Issues Encountered with ASCE Compatibility Criteria

Loyce M. Adams¹, Frank I. González², and Randall J. LeVeque¹

Figure 1. TDG probabilistic co-seismic deformation

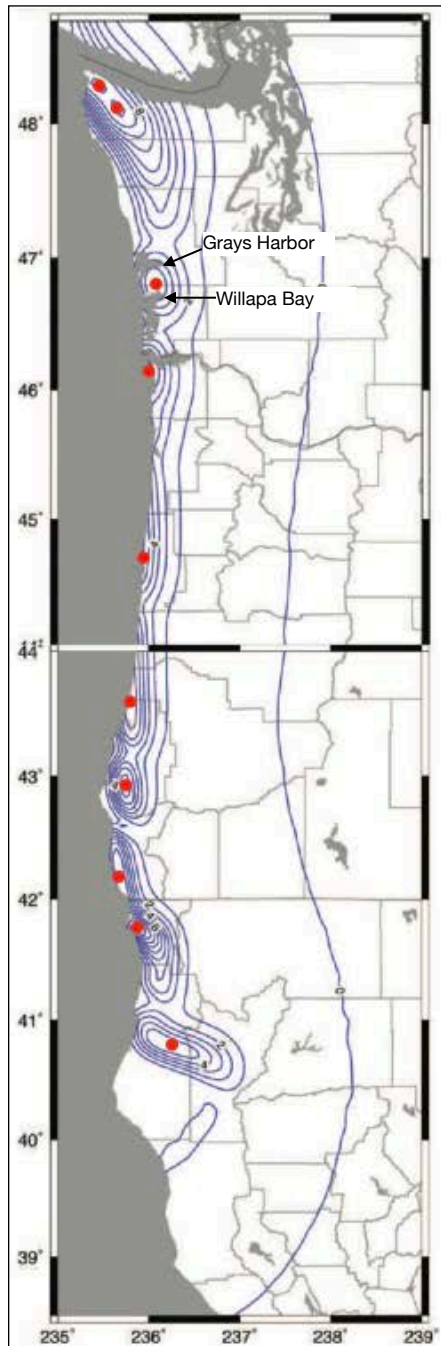
(a) Co-seismic deformation extrema. Prominent extrema in the TDG probabilistic subsidence pattern displayed in Figure 1 were identified as problematic during informal discussions with a TLES member (Thio, H.K., personal communication) and local UW CSZ experts. The TLES member pointed out that the pattern was probabilistic, not deterministic, and thus the extrema might be related to the positioning of a movable asperity model in the PTHA methodology.

Suggestion B: Please develop criteria for VES co-seismic deformation that includes an assessment of the degree to which extrema of probabilistic co-seismic deformation might be due to computational artifacts as discussed above.

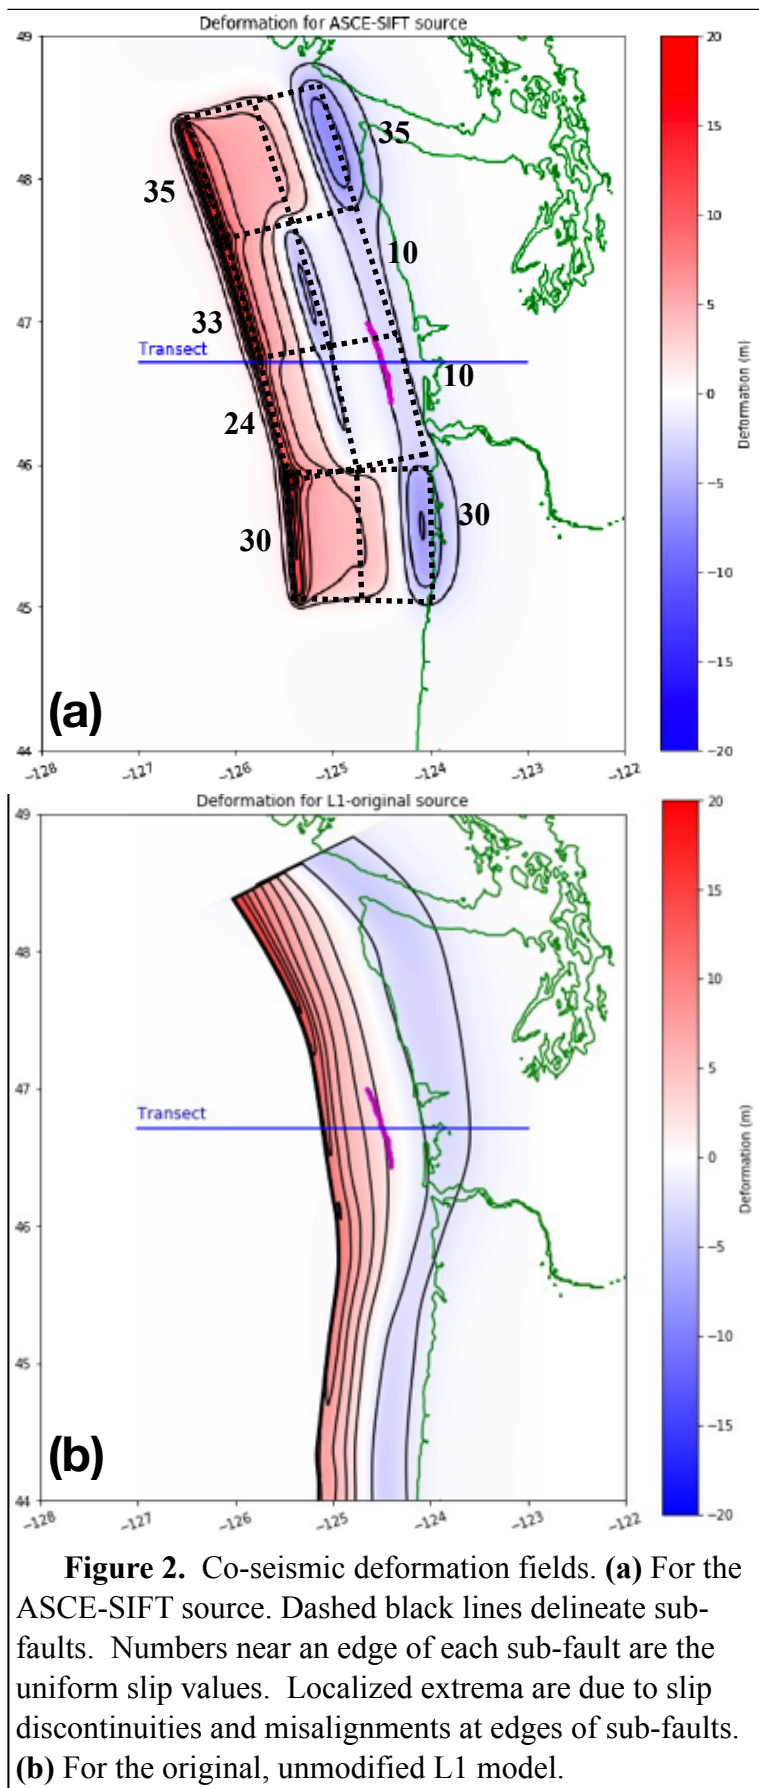
Figure 2 suggests another possible cause of such extrema -- artifacts of slip discontinuities and mismatches at sub-fault edges. Figure 2 (a) presents a co-seismic deformation pattern for seismic model ASCE-SIFT, composed of uniform slip on each of eight 50 x 100 km² Unit Sources of the Short-term Inundation Forecasting of Tsunamis (SIFT) system. This and similar Unit Source seismic models (sometimes specified as Green's functions) were used to initiate inundation simulations for the development of ASCE-compliant Tsunami Design Zones (TDZ) (Wei, et al., 2017; University of Washington Working Group, 2017; ASCE, 2017b); a least-square procedure was applied to specify uniform slip values on each sub-fault that resulted in modeled offshore tsunami amplitude (OTA) values that meet ASCE criteria.

Taken alone, each sub-fault in Figure 2 (a) produces a typical subduction zone thrust event deformation pattern with positive and negative extrema located at the top and bottom down-dip edges, respectively (see, e.g., <https://www.clawpack.org/geoclaw/Okada.html>). Linear summation of such patterns can introduce features at sub-fault length scales that are associated with slip discontinuities and misalignments at neighboring sub-fault edges. We see this effect in the ASCE-SIFT deformation pattern, in which the greater the edge discontinuities and mismatches, the larger the pattern distortion and likelihood that additional extrema will be discernable; these effects are, of course, a matter of degree because they cannot be entirely eliminated in discrete computations.

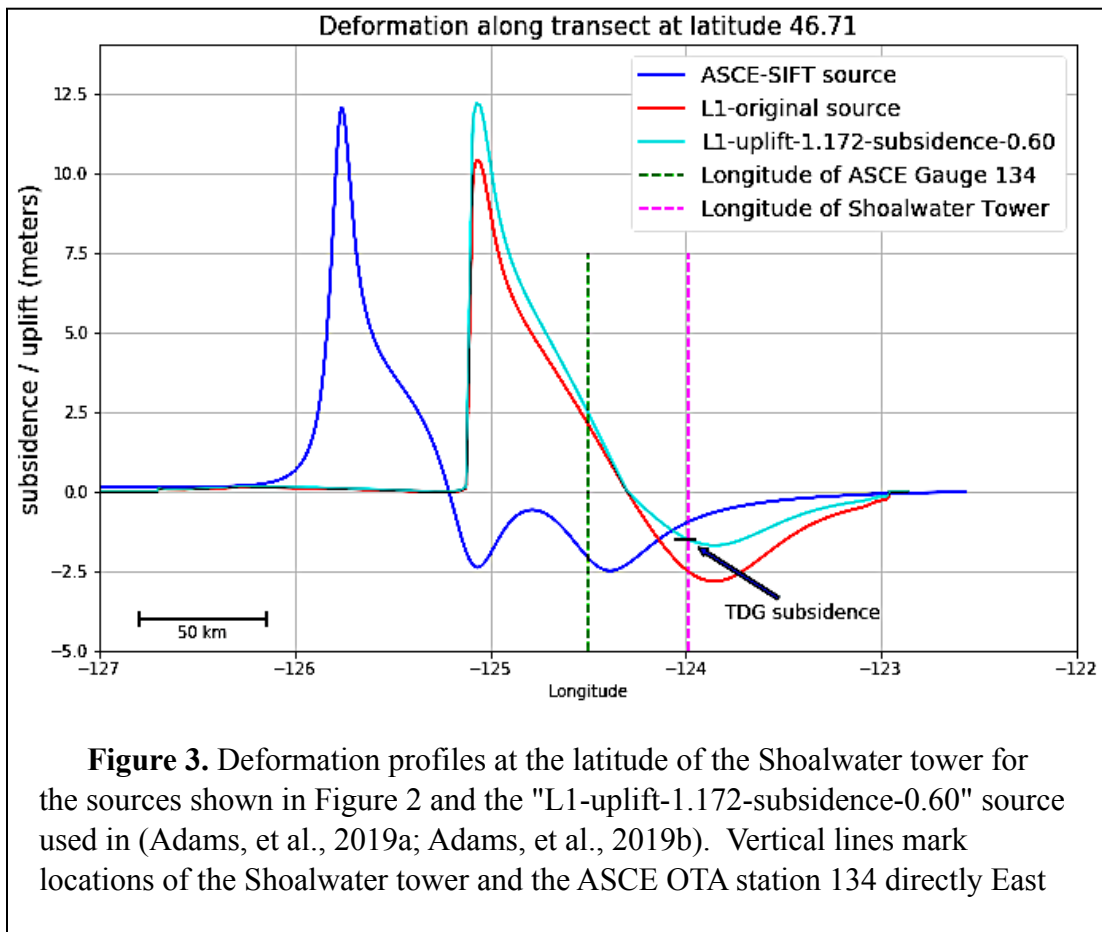
One of the TDG extrema in Figure 1 overlays our current study sites of Aberdeen in Grays Harbor and the Shoalwater-Tokeland area in Willapa Bay. Figure 3 presents East-West co-seismic deformation profiles that cross the Shoalwater VES site at latitude 46.71° N. The source designated "L1-uplift-1.172-subsidence-0.6" increases uplift by 17.2% to meet ASCE OTA criteria and reduces subsidence by 40% to match the ASCE TDG value at the Shoalwater VES site.

Note that there are two major differences in this model profile and that of the ASCE-SIFT model: the subsidence differs by a factor of 1.5 and there is also more than a fifty kilometer difference between the peak uplift location of these two models. Figure 3 is thus a clear example of the significant differences in seismic models that can occur in spite of the fact that they are each ASCE-compatible. Clearly, co-seismic deformation, whether uplift or subsidence, is critically important in the VES site selection process and in the subsequent structural design and engineering; the locations of offshore extrema relative to the VES site are also an important factor in this decision-making process, since the associated distances to VES sites govern the time available for evacuation of residents to the safety of the VES.

Suggestion C. Please develop a suite of TDZ seismic models for ASCE 7-16 source regions that meet both co-seismic deformation and OTA criteria and provide users with the detailed specifications needed to recreate these ASCE-compliant seismic models for use in VES site assessment studies

Figure 4. Proposed changes to Figure 6.14-1 that have been approved as a revision to ASCE 7-22. Not explicitly displayed are co-seismic deformation and SLR, which must be taken into account.

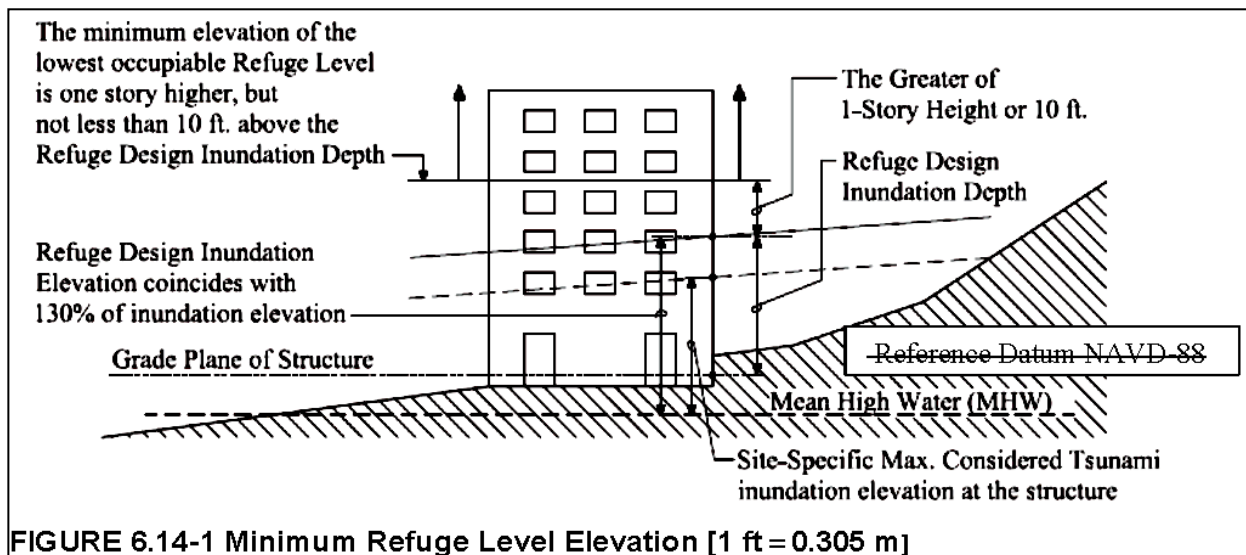
In addition, we note that Figure 4, which presents Figure 6.14-1 of the TLES-approved ASCE Change Proposal *TS-CH06-04r00*, does not explicitly include graphic representations of co-seismic deformation (CD) (subsidence or uplift) or sea level rise (SLR). Both SLR and CSD must be accounted for as stated in Sections 6.5.3 *Sea Level Change* and 6.7.6.2 *Seismic Subsidence before Tsunami Arrival*, respectively, in the computation of "Site-Specific Max. Considered Tsunami inundation elevation at the structure [SMIE]" and thus the "minimum elevation [ME] of the lowest occupiable Refuge Level [LORL]". We explicitly model SLR and CD in our VES modeling studies and thus they are implicitly included in the criteria for SMIE and ME, which is given by the relationship

Note that the Grade Plane (GP) of Structure in Figure 4 is not the underlying level of topography; rather, the definition in Section 6.2 *DEFINITIONS* states that it is "*... the average elevation of finished ground level adjoining the structure at all exterior walls ...*" with additional instructions for including sloping or more complex topography outside the walls. Also, this SMIE definition is apparently the same as that for "*INUNDATION ELEVATION: The elevation of the design tsunami water surface, including relative sea level change, with respect to vertical datum at Mean High Water (MHW).*" We assume that "*relative sea level change*" is SLR. Although Figure C6.1-2 does include both SLR and co-seismic deformation, we found it difficult and time-consuming to search through Chapter 6 and the associated Commentary to clarify the inclusion of SLR and co-seismic deformation in the modeling. We feel that the Chapter should be self-contained, presenting both textual explanations and illustrative graphics for all basic requirements and criteria.

Suggestion D: Please follow the example of Figure C6.1-2 and revise Figures 6.2.1, 6.6.1, and 6.14.1 to explicitly indicate possible SLR and co-seismic deformation at the VES site.

Figure 5. Hypothetical VES modeling study in which subsidence drops the structure below MHW and MCT is small. MHW is the reference level, B is the topography, η is the tsunami amplitude and h is the total water depth. See text for discussion.

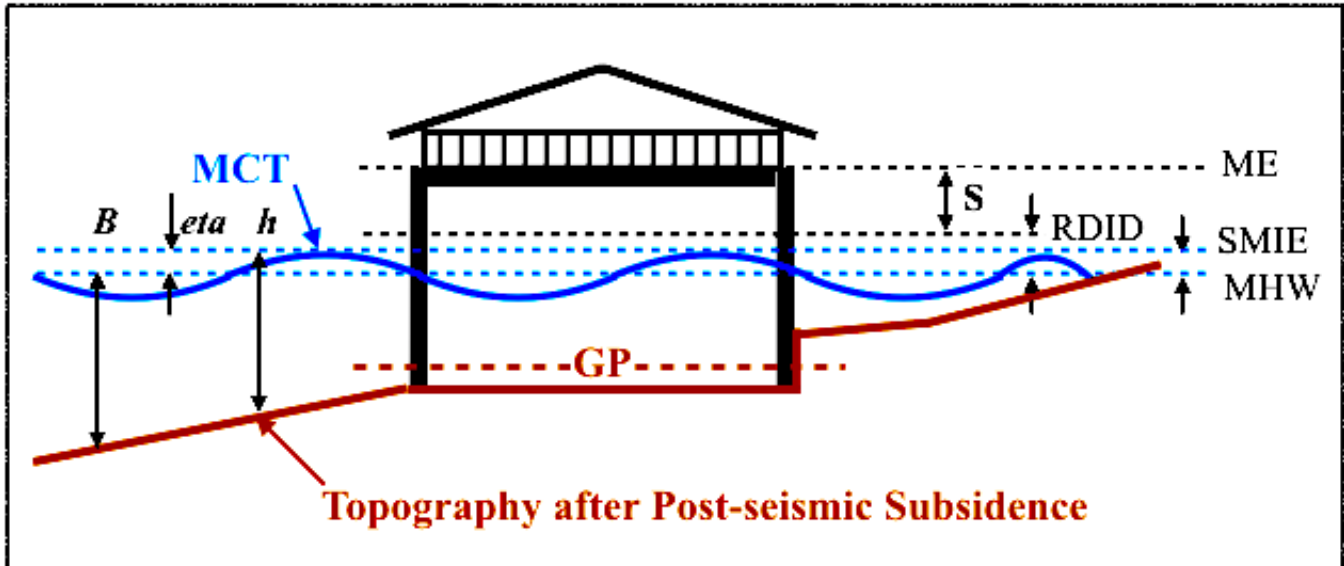
In Aberdeen, WA, our on-going study of the proposed VES site demonstrates that subduction can lower a structure below MHW. Figure 5 portrays the Aberdeen situation schematically, in which the subsidence is relatively large and lowers the structure below MHW but the MCT amplitude is small at the VES site. This is a somewhat counter-intuitive and unexpected scenario, but can occur in locations such as Aberdeen. The tsunami, although much larger at the coast, travels through Grays Harbor and overland before reaching the structure, and has a flow depth that is less than the subsidence at the proposed VES location.

The SMIE and RDID are thus correspondingly small, although the addition of the safety factor S results in an ME that prevents flooding of the LORL by raising it above MHW and the MCT (see Figure 5).

Suggestion E: Please consider the concerns raised here regarding equation [1], including the possibility that the term $1.3 \cdot \text{SMIE}$ does not provide the intended level of safety for very small SMIE, especially when the flow depth h at the structure is greater than SMIE. Also, please provide the rationale for the term $S = \max(10 \text{ ft}, 1 \text{ story})$ and, if appropriate, discuss this issue in the Commentary.

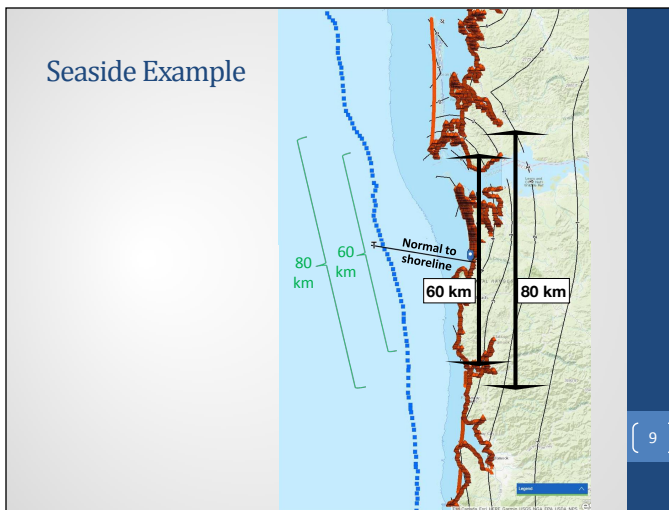
(1) "the extent shall include points within at least 60 km..." Due to the use of the word "within," this could be interpreted to mean the extent should include points in a circle of radius at least 60 km centered at some point, since all of these points are within 60 km of the center. We suggest clarifying to say the *length* of the extent should be at least 60 km, not that it should include points within 60 km.

(4) One way to interpret the intent of this wording might be to go offshore in the normal direction from the VES to the nearest gauge, and then use all gauges within a circle of radius 30-40 km centered on this gauge. The green lines on Figure 6 seem to indicate this. [Figure 6 is taken from slide 9 of the webinar presentation "Technical Briefing on 5 upcoming Chapter 6 Ballot Items Update Cycle for the ASCE 7-22 Standard," G. Chock and I. Robertson, 12 September 2018]. We have also added black lines to this figure to indicate extents of length 60 and 80 km along the coast (corresponding to circles of radius 30-40 km centered on land). Because the gauges run roughly parallel to the coast in this region, the projection of the green lines is similar to the black lines, but this depends on the topography of the continental shelf and may not always be true.

(5) Part (a) quoted above says "...centered within a tolerance of plus or minus 10 km on the site", which seems to imply the black lines in Figure 6, whereas part (c) goes on to say "For sites within bays, the designated center of the computed offshore tsunami amplitude points shall be taken...", which makes it sound like circles are to be centered at an offshore gauge rather than at a point on the shore, i.e. the green lines in Figure 6.

Suggestion G: Please clarify this wording, and we suggest adding a figure with an example or two to the standards document to help users understand the intent.
